**THREE-SIXTEEN**

**QUAD-CITIES NUCLEAR STATION  
MISSISSIPPI RIVER**

A DEMONSTRATION TO THE UNITED  
STATES ENVIRONMENTAL PROTECTION AGENCY BY THE  
COMMONWEALTH EDISON COMPANY UNDER SECTIONS  
316a and b OF THE FEDERAL WATER POLLUTION  
CONTROL ACT FOR THE QUAD-CITIES NUCLEAR  
STATION AT CORDOVA, ILLINOIS ON THE  
MISSISSIPPI RIVER

## Errata

Figure 32. Total phytoplankton counts compared above and below Quad-Cities Station, April 1971 through July 1974.

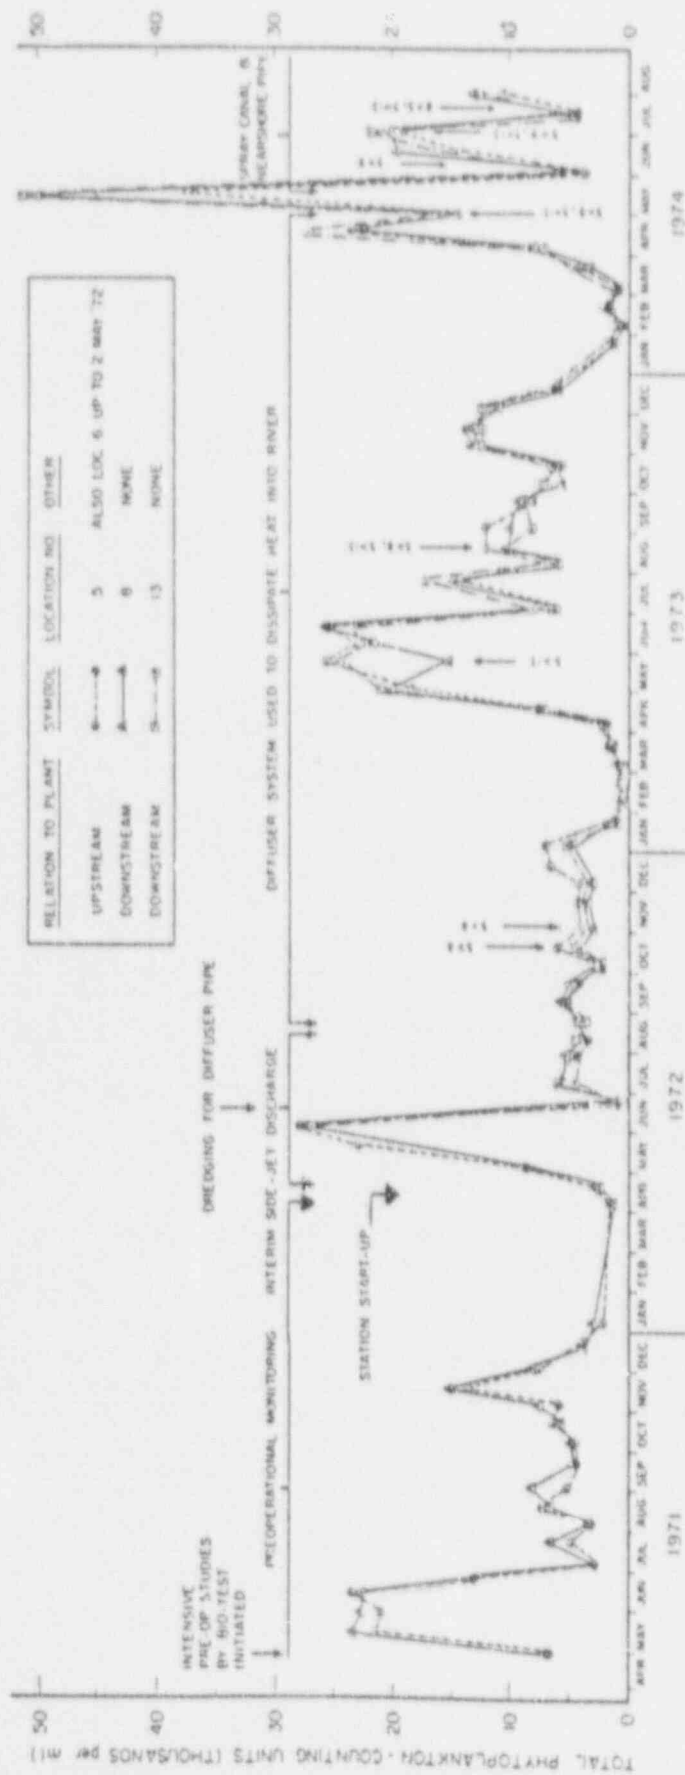
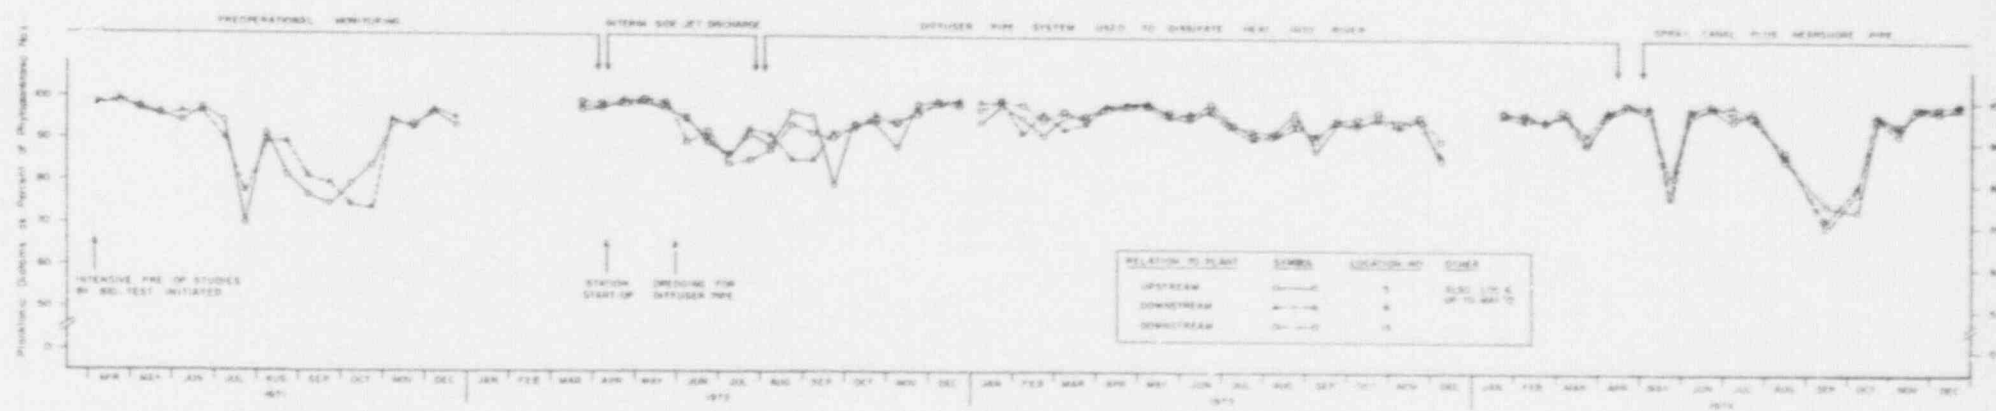
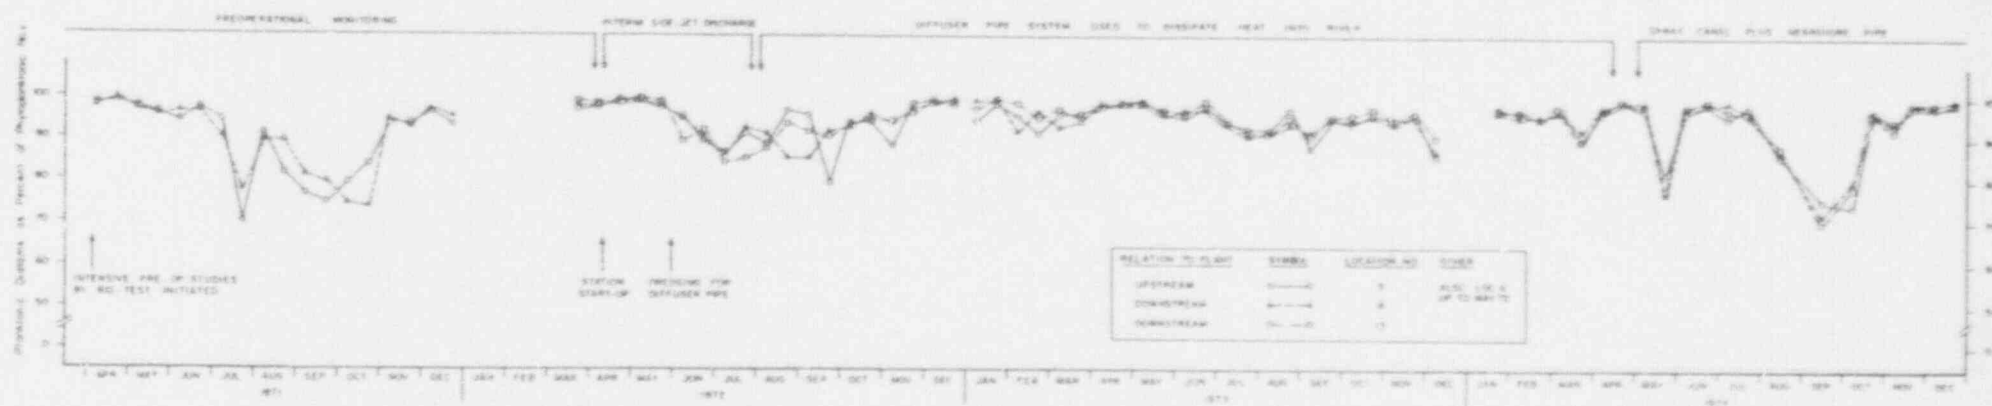
<u>PAGE</u>	<u>LINE</u>	<u>CHANGE</u>
141, 141	Figures 32, 33	original 316a graphs are updated by page 313 (Figures 7.5 and 7.6ff) taken from the latest semi-annual report to Commonwealth Edison on biological monitoring by Nalco Environmental Sciences. The following updated list of significant differences applies to Figure 7.5 of the semi-annual report, and Figure 32 of the 316a (p. 144):  16 October, 1972      5>8 6 November, 1972      5>8 20 March, 1973      13>5 21 August, 1973      5>8; 5>13 2 May, 1974      8>5; 13>5 2 June, 1974      8>5 2 July, 1974      8>5; 13>5 15 July, 1974      8>5; 13>5 21 November, 1974      13>5
145	13	Change Ochener to - Ochsner
147	Figure 34	original 316a graph is updated by page 315 (Figure 7.7) from the latest semi-annual report which follows this section.
148	Figure 35	original 316a graph is updated by page 316 (Figure 7.8) from the latest semi-annual report which follows this section.

Figure 7.5. Comparison of mean phytoplankton density at upstream Location 5 and downstream Locations 8 and 13 near the Quad-Cities Station, April 1971 - December 1974.

Figure 7.5. Comparison of mean phytoplankton density at upstream Location 5 and downstream Locations 8 and 13 near the Quad-Cities Station, April 1971 - December 1974.

Figure 36. Total zooplankton counts compared above and below Quad-Cities Station, May 1971 through July 1974.

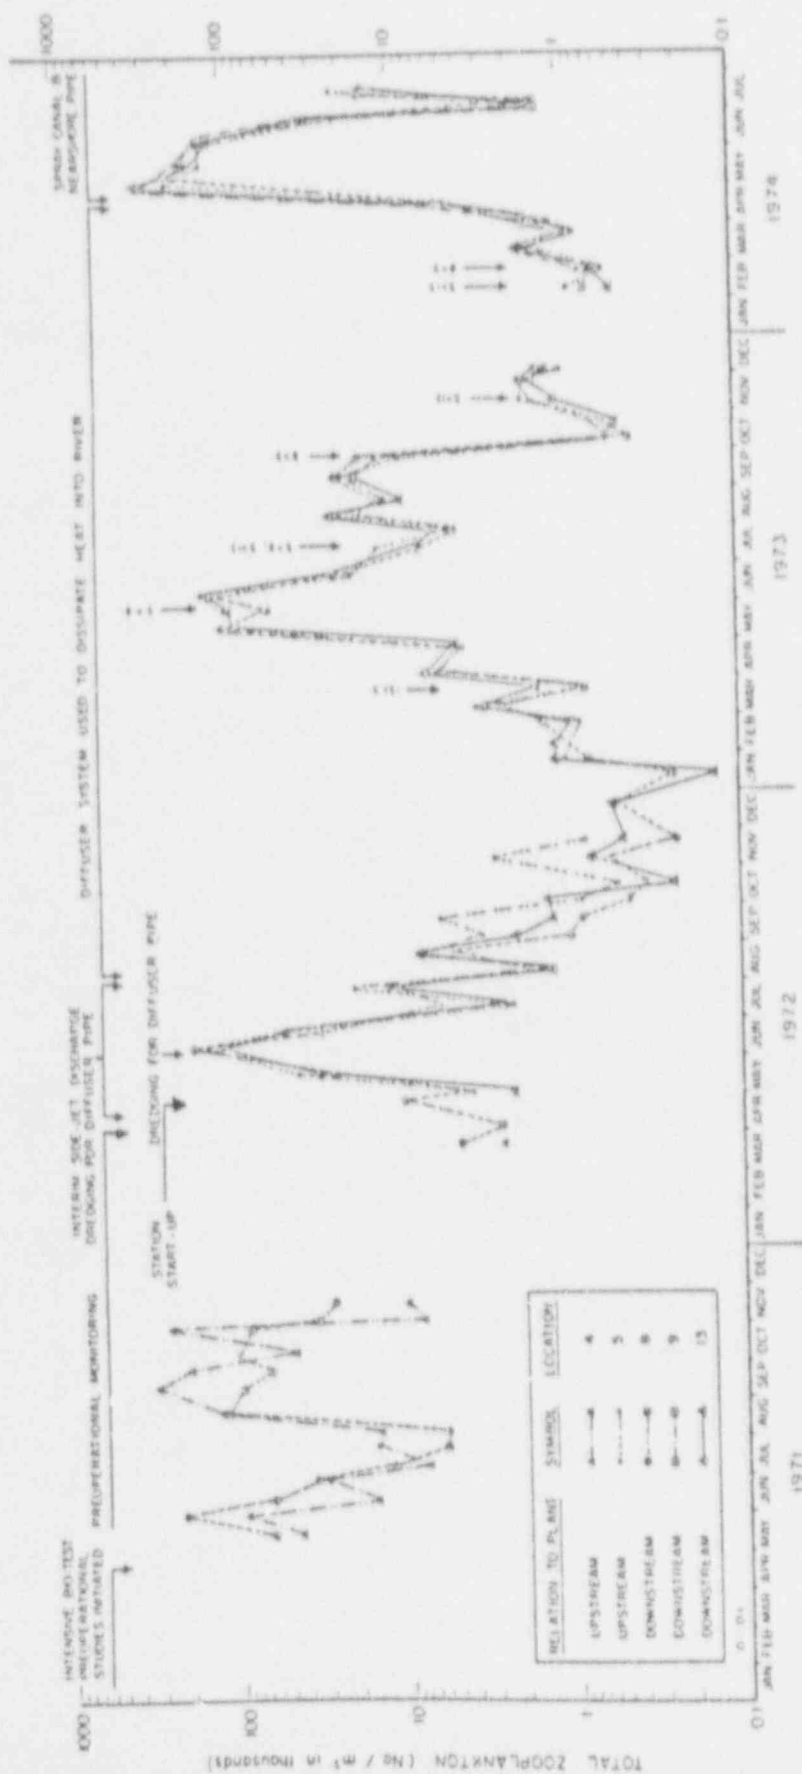
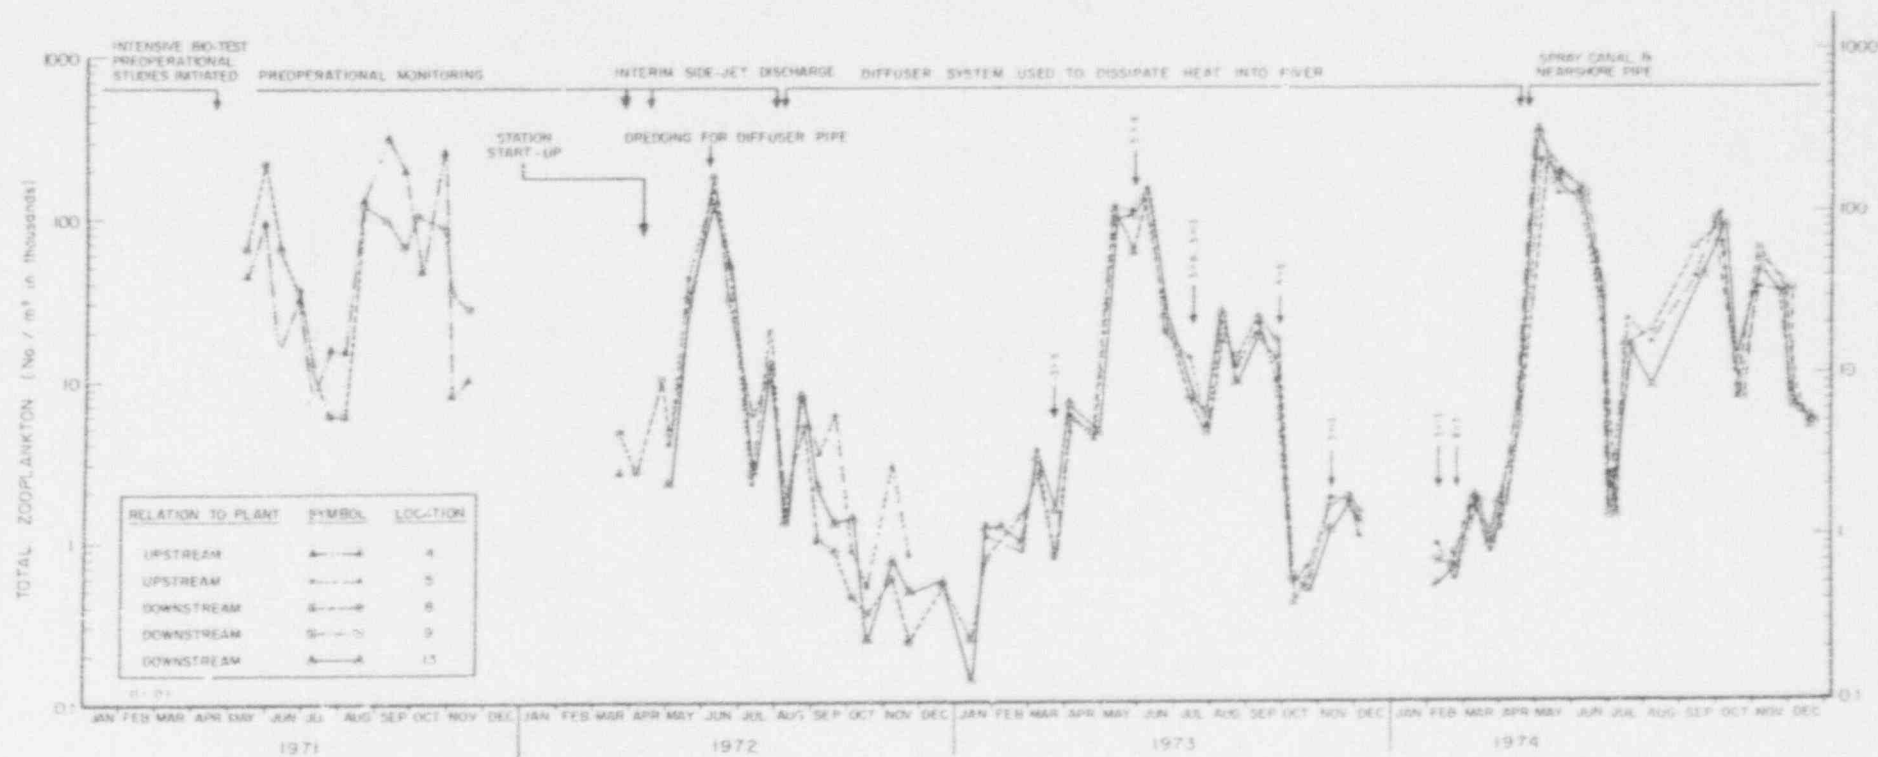
149	Figure 36	original 316a graph is updated by page 393 (Figure 9.3) from the latest semi-annual report which follows this section. The following list of significant differences applies to the updated 1974 portion of the Figure:  1 April      8>5; 13>5 17 May      9>5 15 July      5>8; 5>9; 5>13 6 August      5>13; 8>13 11 September      8>5 2 October      13>5; 13>9 18 October      13>5; 13>9 4 December      8>9; 8>13

Figure 9.3. Density of total zooplankton in the vicinity of the Quad-Cities Station, 1971-1974.
